REMARKS

Application No.: 10/667,360 Docket No.:8733.924.00

AMENDMENTS TO THE DRAWINGS

FIG. 6

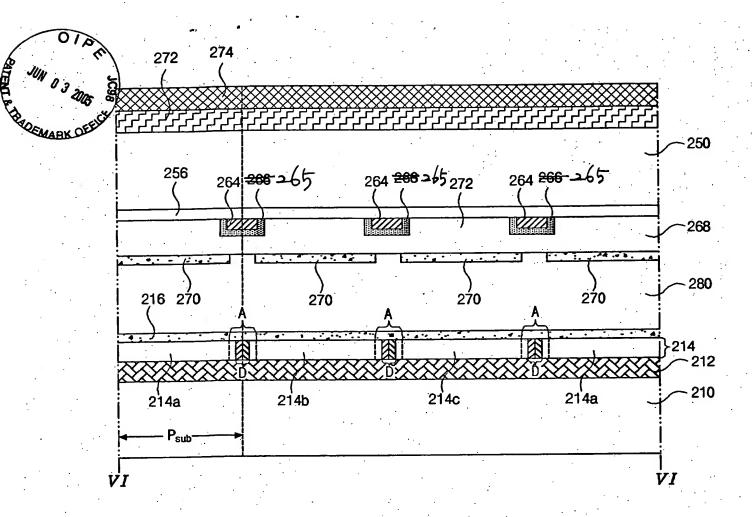
In Fig. 4B, the reference number "112" is changed to "142"; In Fig. 6, the reference number "266" is changed to "265"; and In Fig. 10, the reference number "456" refers to the gate insulating layer, not the passivation layer.
